# Meadowlake Industrial Park Filing No. 1 Preliminary Plan Traffic Impact Study

EPC PCD File No. SP236  
LSC #S234040

# LSC Responses to TIS Redline Comments

Figure 2  
Site  
Plan

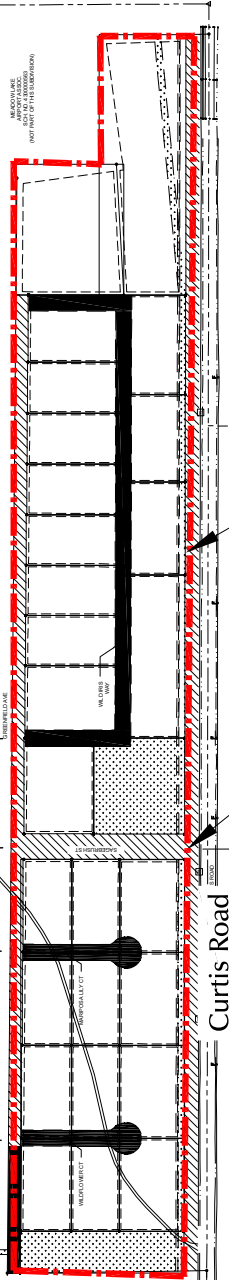
330' is shown on the  
prelim plan. Please  
verify and coordinate  
with the planner to  
ensure the  
intersection distances  
are consistent and  
meet criteria.

Author: jchodsdon Subject: Sticky Note Date: 11/15/2024 2:26:43 PM  
LSC Response: Corrected on the updated figure.
